**Model:** SR6001, SR7001 SR8001

**Subject:** The thermal sensor is sometimes activated, which shuts down the unit putting the unit into standby.\*

Fig.1

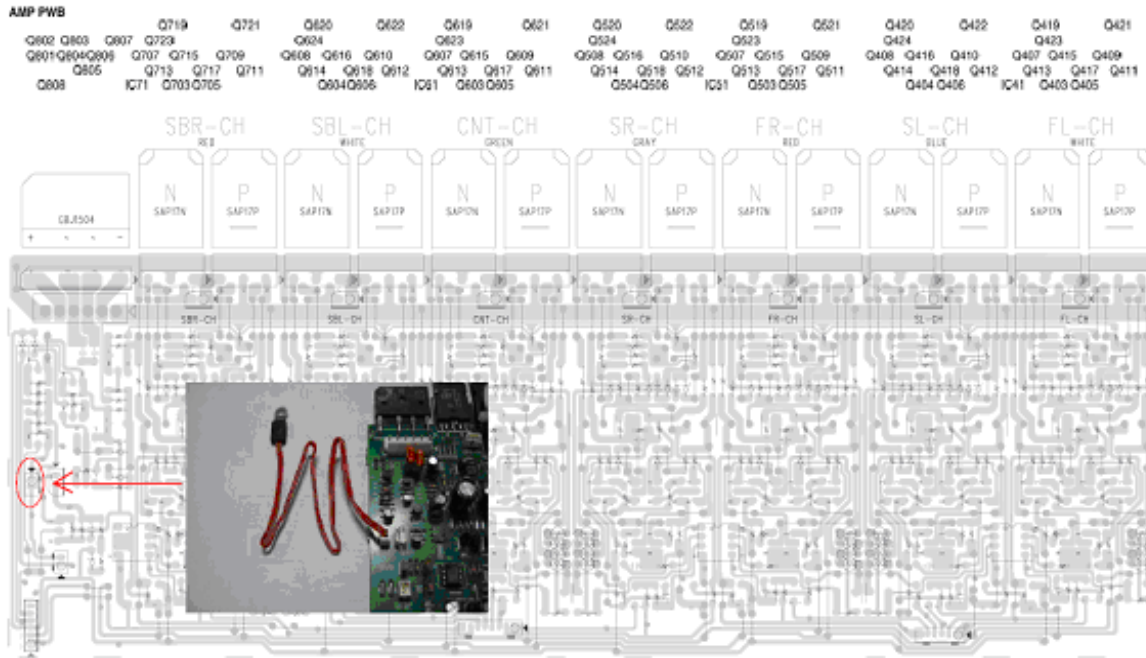
2. Cut the white plastic connector (CN81) off the new Heat Sensor then strip ¼ inch (approx.) of insulation from the end of the lead and tin each end of the lead wire. (Fig. 1)

Fig.2

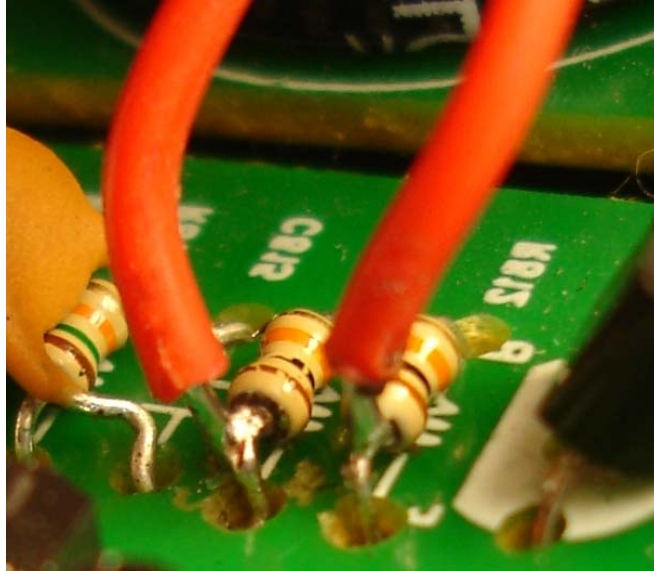
3. Solder the stripped ends of the lead wires to resistors R811 and R812 as shown below.

Fig. 3

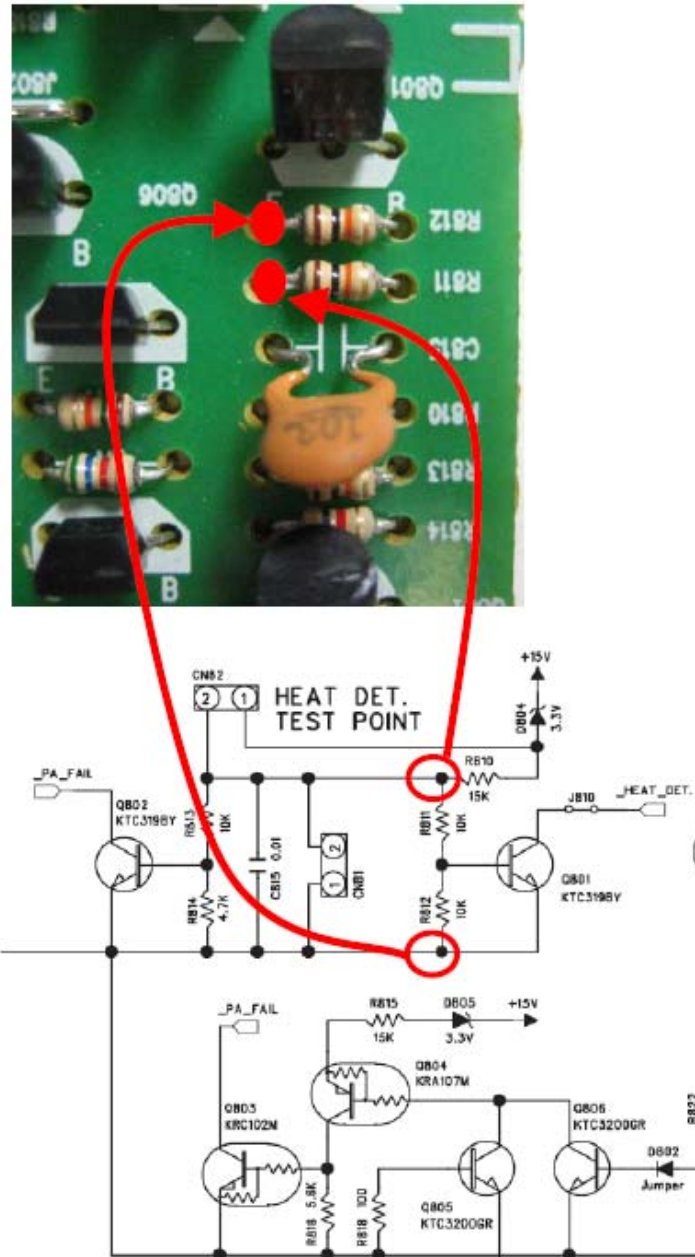
**Note:** The Heat Sensor has no polarity however, be certain to connect the sensor to the side of each resistor that corresponds (electrically) to connector CN81's pins 1 & 2. Do not solder the leads to the side of resistors R811 and R812 that are closest to the base of transistor Q801. See Figure 3 for details.

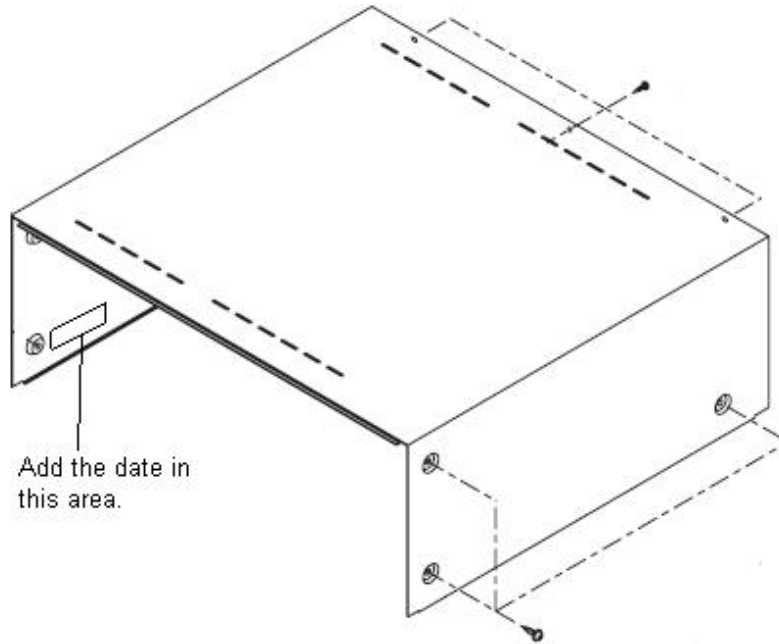
4. Fix the soldered wire ends to the resistors using Sony® bond SC608Z or Dow Corning® SE 9188 RTV high temperature RTV.
